1.问题点Question

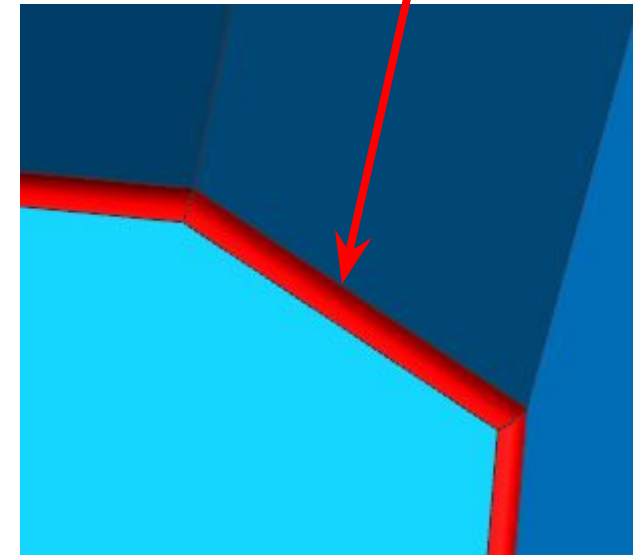
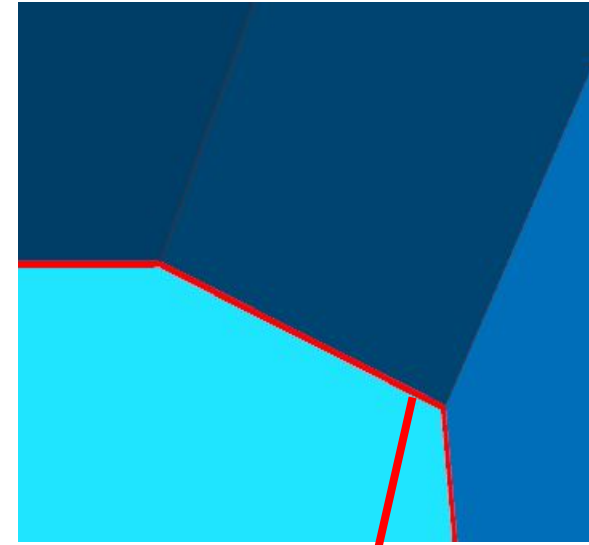
The red line of the product is a sharp corner, the product is not easy to produce, it is recommended to add a round corner of R2mm as shown in the figure. please confirm if it is okay?

2.问题点Question 2

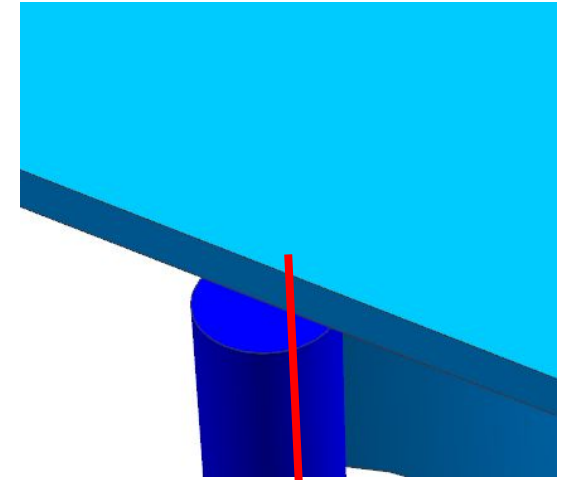
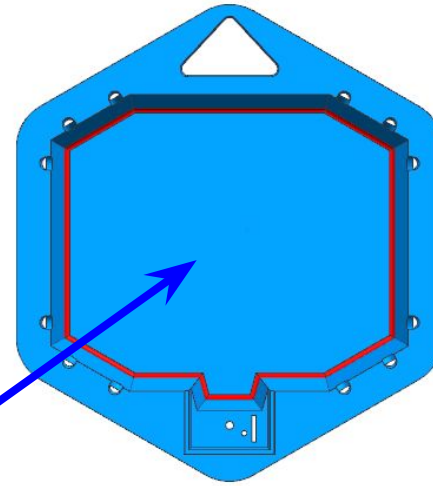
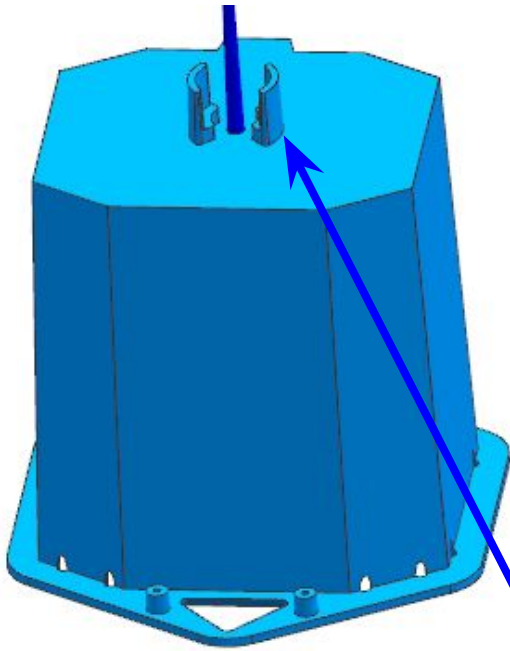
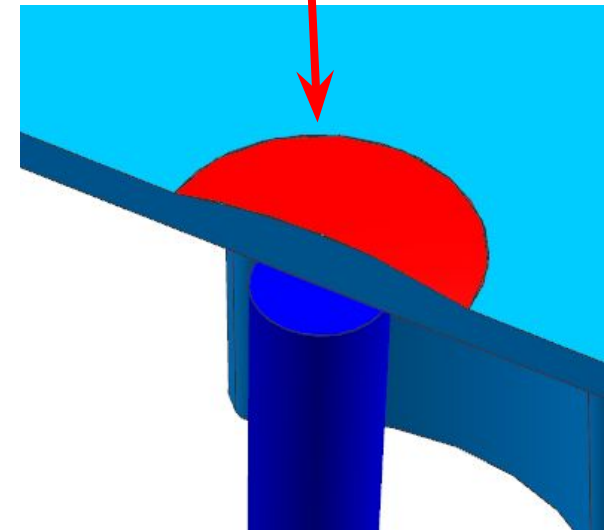
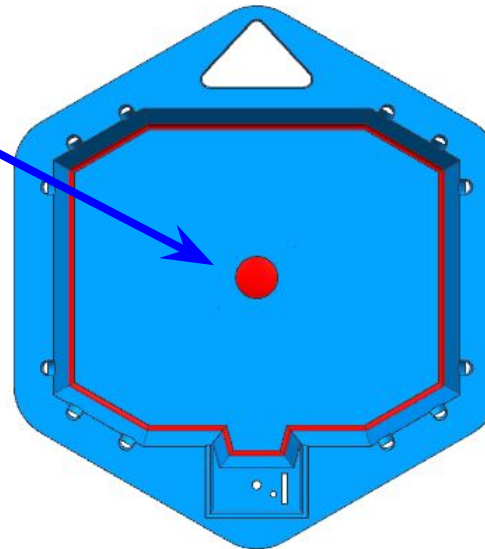
The blue shape is the position of the glue point, it is recommended to add a 14X1mm diameter boss in the red area of the product as shown in the figure to facilitate product production. please confirm if it is okay?

3.问题点Question 3

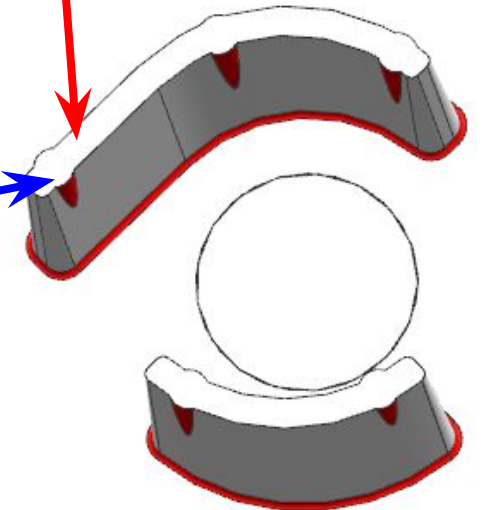
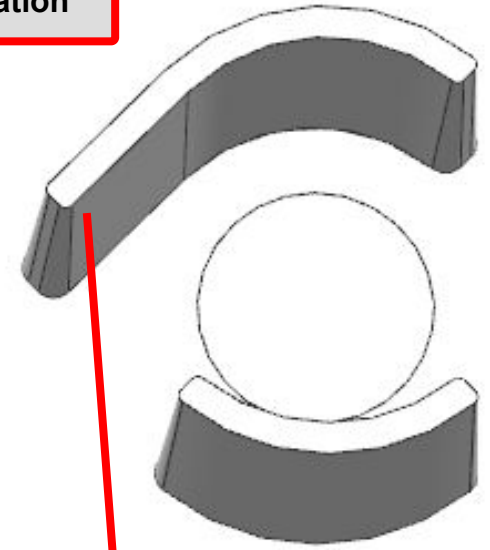
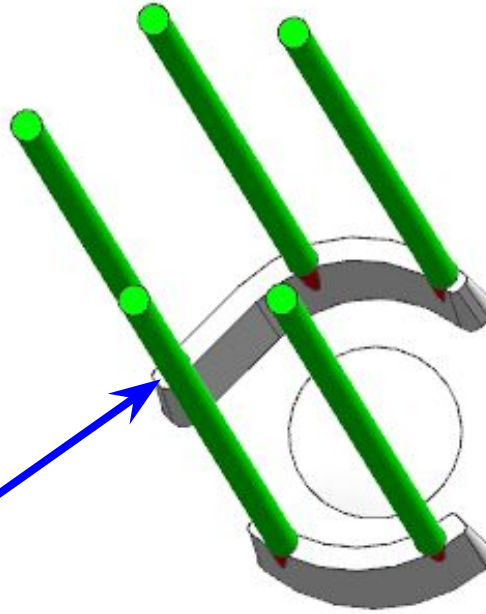
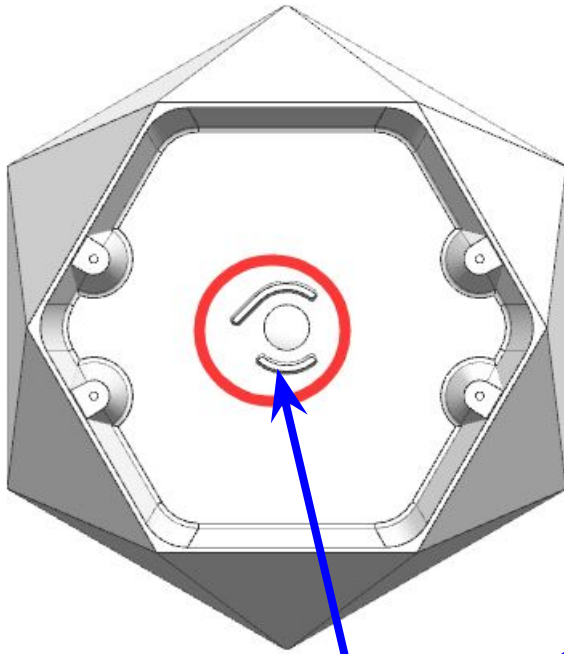
The shape inside the red circle is easy to break and difficult to eject. It is recommended to add R0.5mm at the bottom and add 5 pieces 3mm eject pin. The product is suggested to add thickness in the red area as shown, please confirm if it is okay?

4.问题点 Question 4

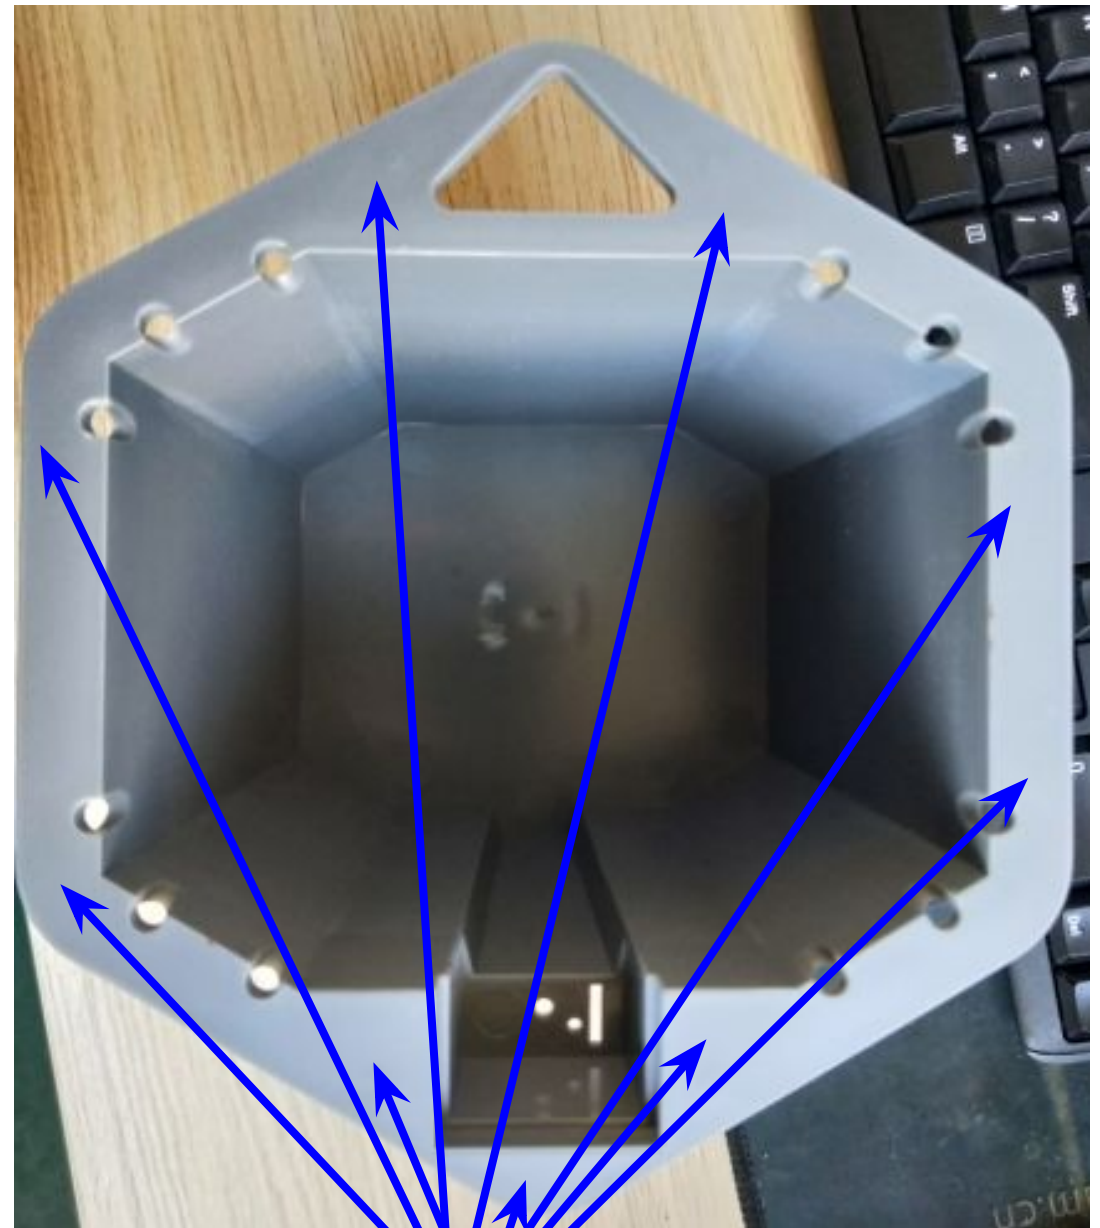
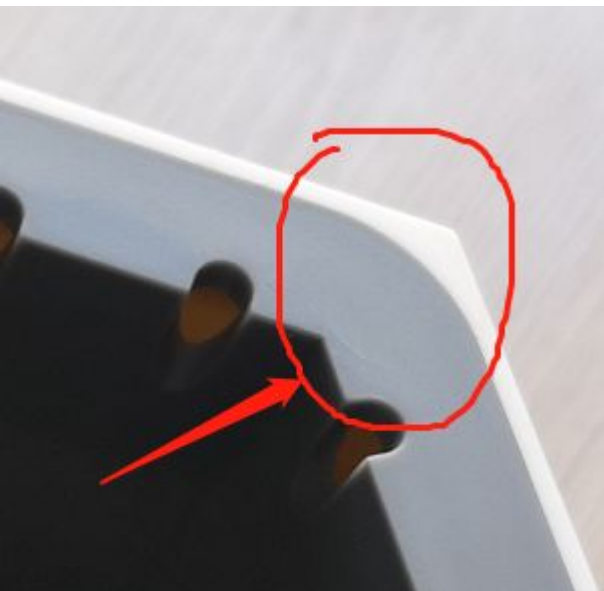
The product has the problem of welding trace and pin mark . Corresponding to the mold position, it needs to be dug out and re-welding.

5.问题点Question 5

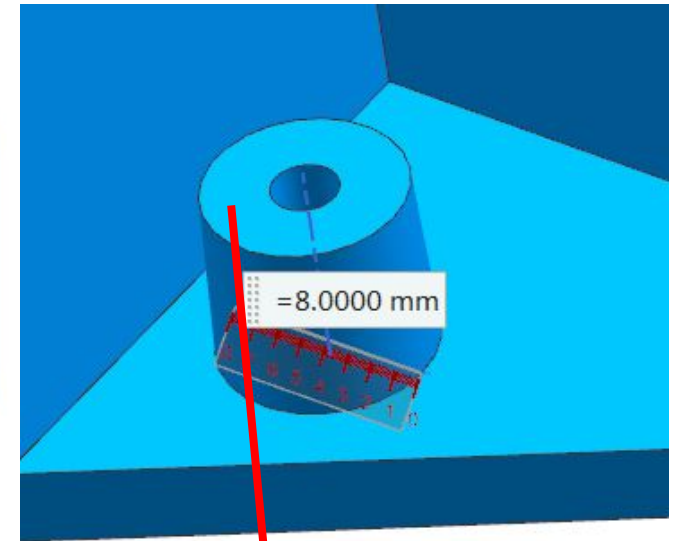
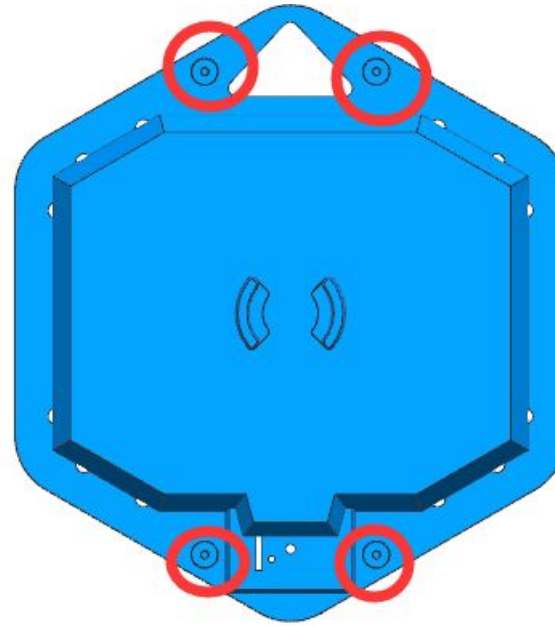
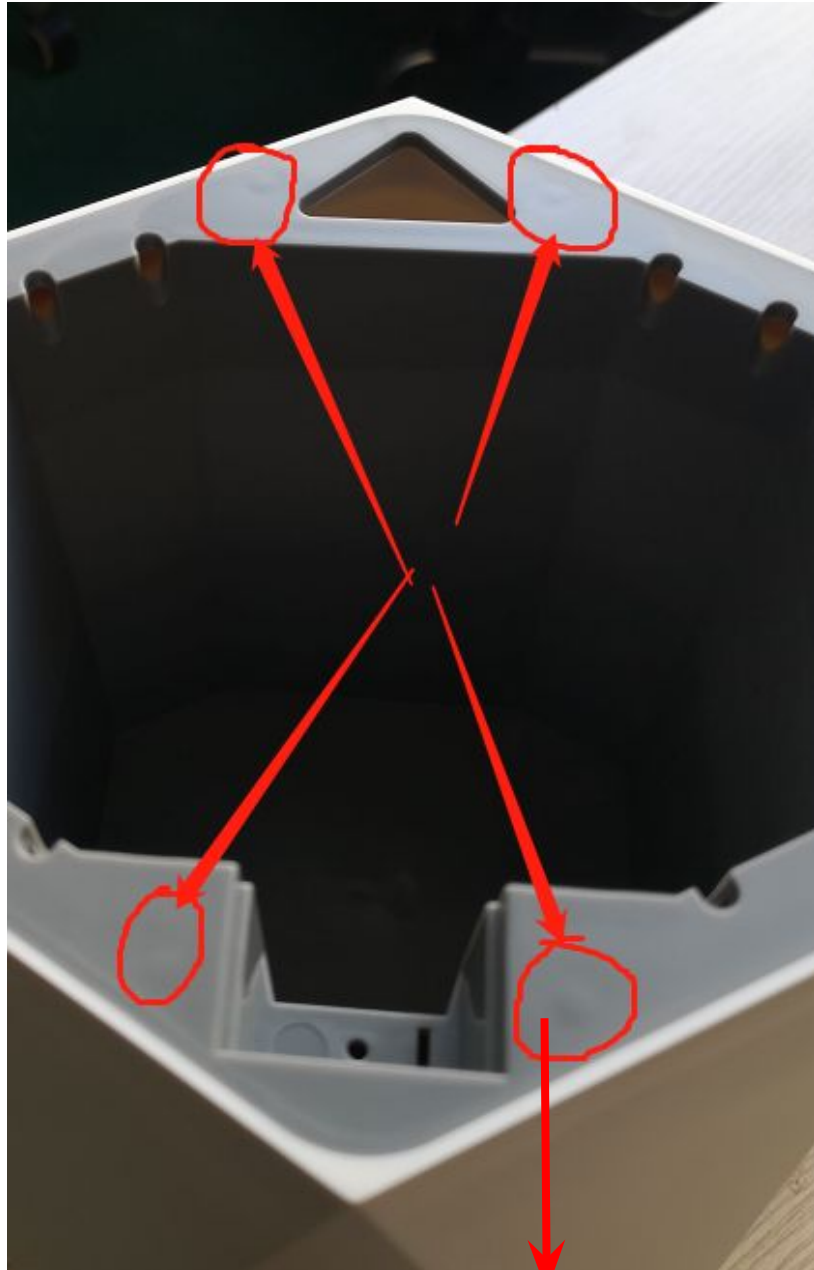
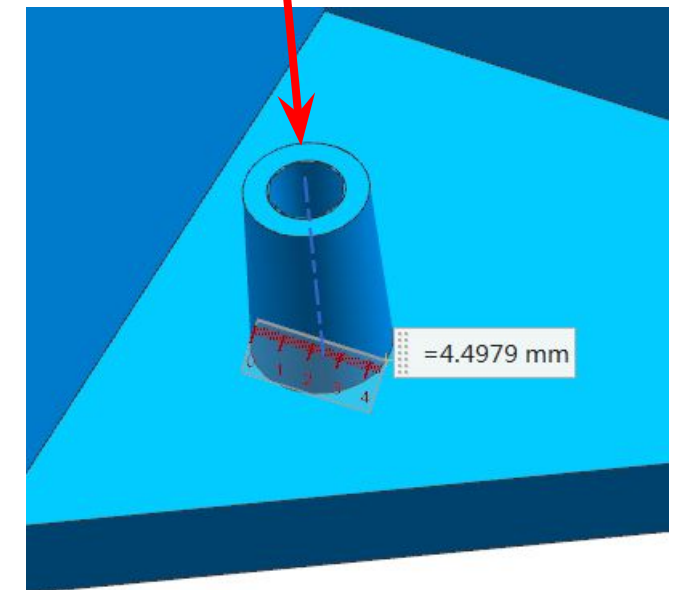
There is shrinkage at 4 places of the product. It is recommended that the diameter of the cylinder be changed from 8mm to 4.5mm to reduce shrinkage. if it is okey ?

6.问题点Question 7

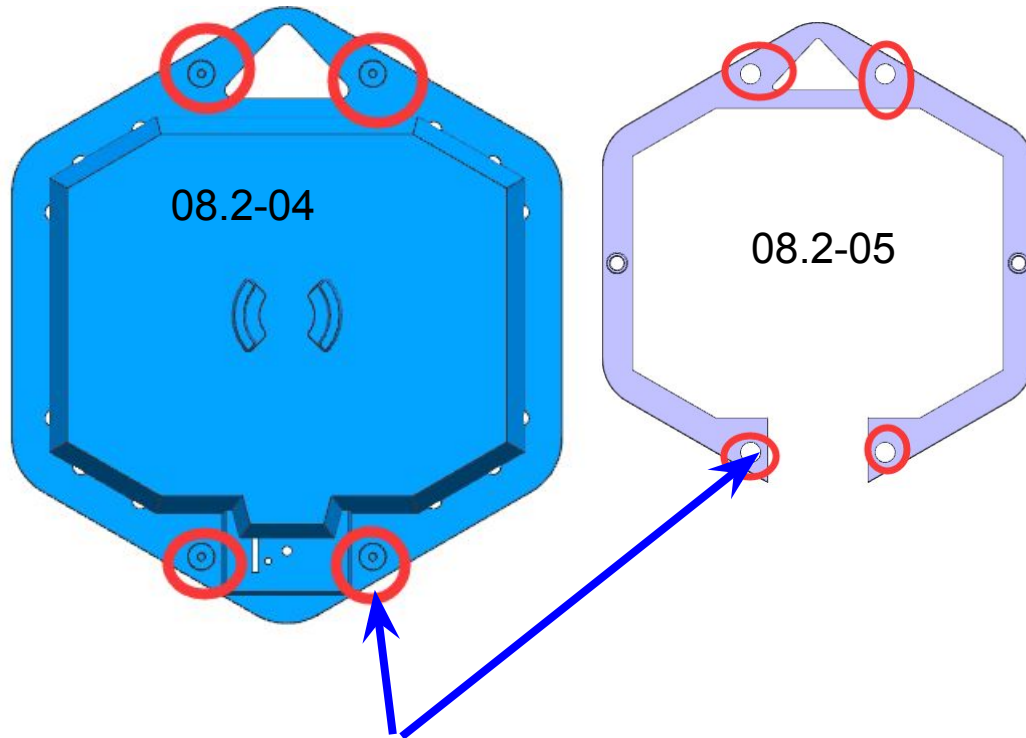
08.2-04, if the position of the cylinder is modified, and the size of the circular hole corresponding to 08.2-05 must also be modified together, as shown in the figure. if it is okay?

Solve the above 3-6 points: add eject pin, welding, modifying BOSS hole, the cost: 380USD, please refer to the quotation for details.

7.问题点 Question 7

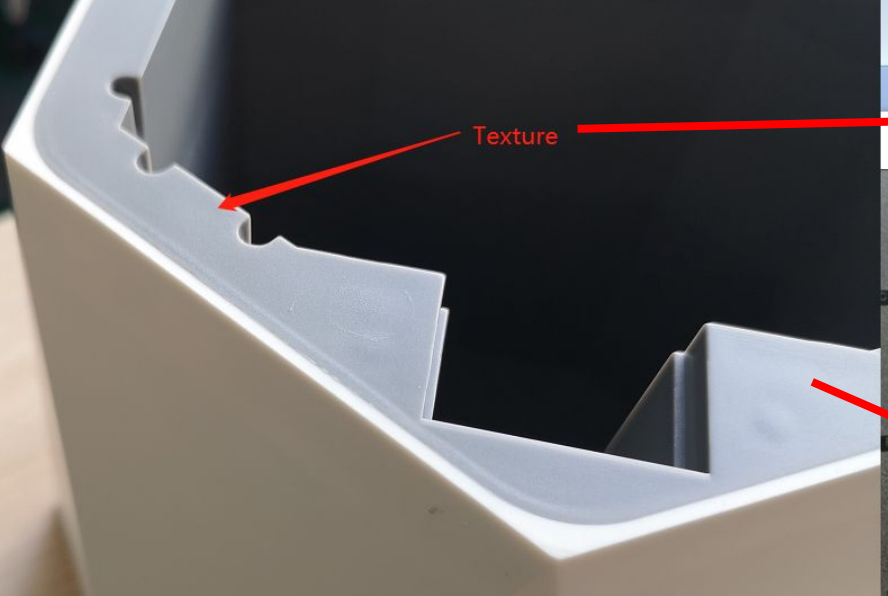
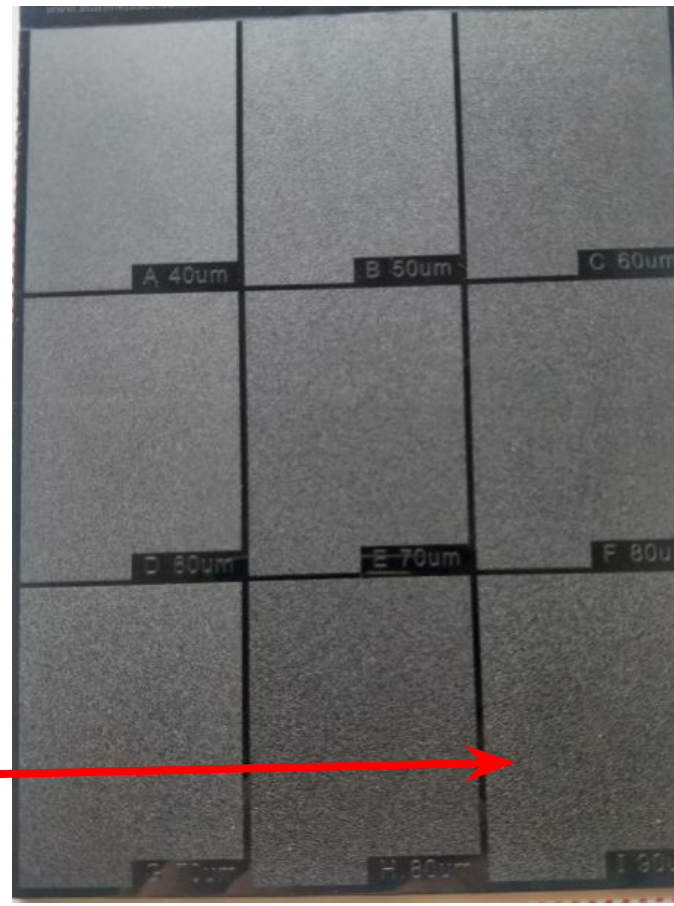
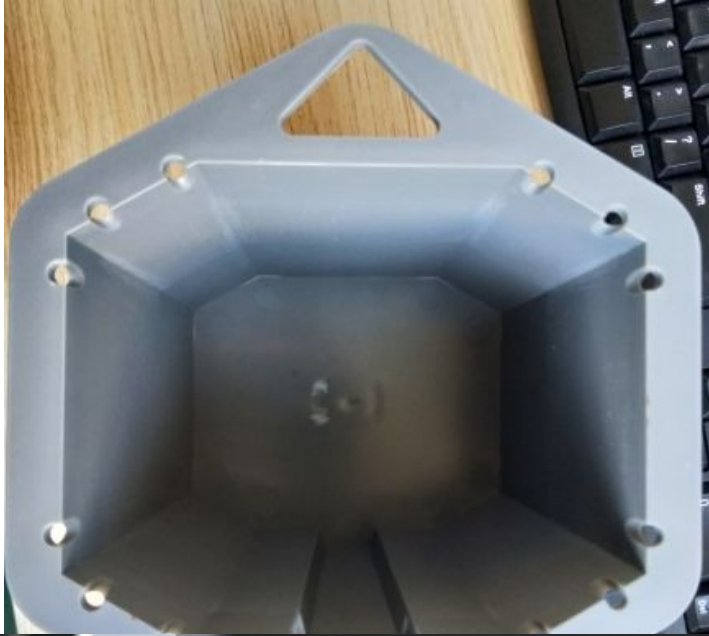
There is a eject pin mark on the surface of the product. It is recommended that the surface treatment of the product be changed from VDI24 to I90UM. It will

In order to solve the eject pin mark left by the previous mold welding, we will remake the matte surface, the cost: 530USD, please refer to the quotation for details. (Note: It may not be completely no trace, but it will improve.) If it is okey ?

1.问题点 Question

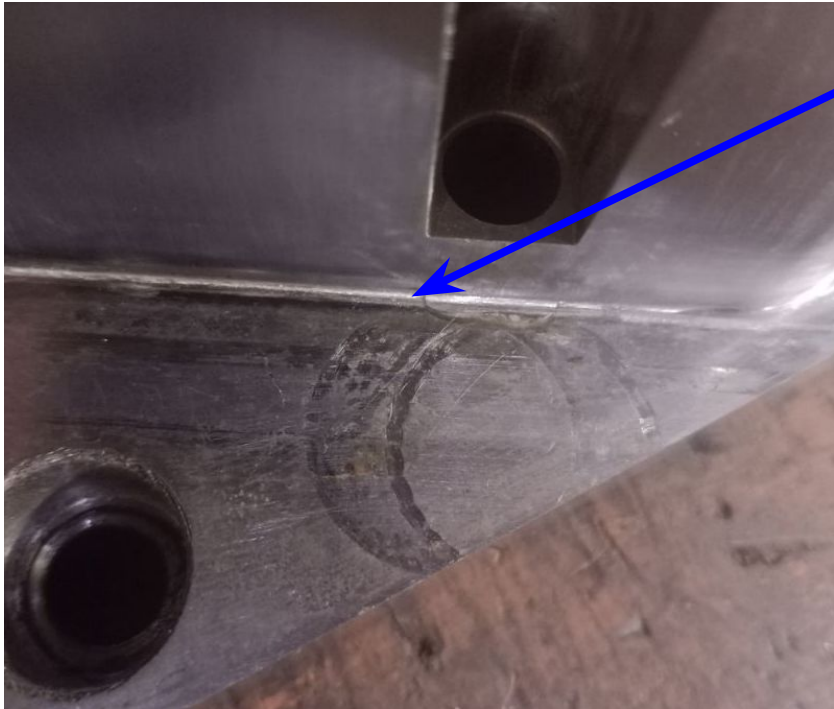
There are many places where the mold has been welded by RJC before of another half mould. There will be marks on the surface of the product. Please know and confirm?

2.问题点question 2

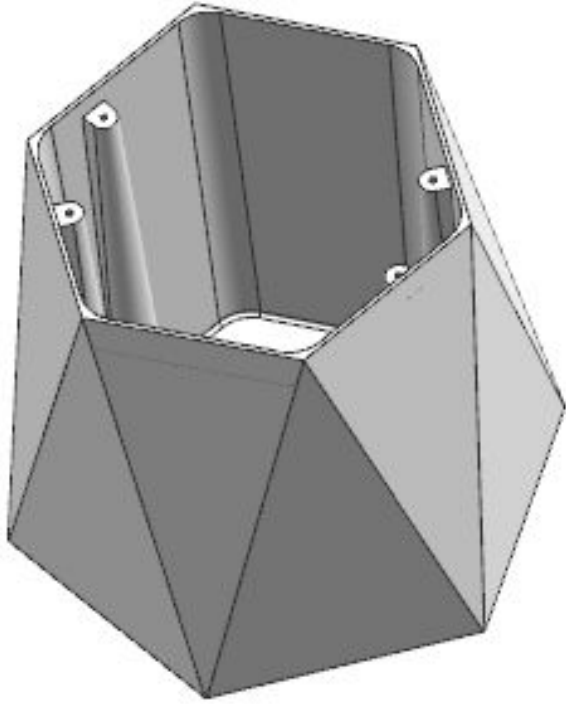
The template on the mold is very thin and deformed before, and the product is prone to burrs. We have replaced new template. Please know.
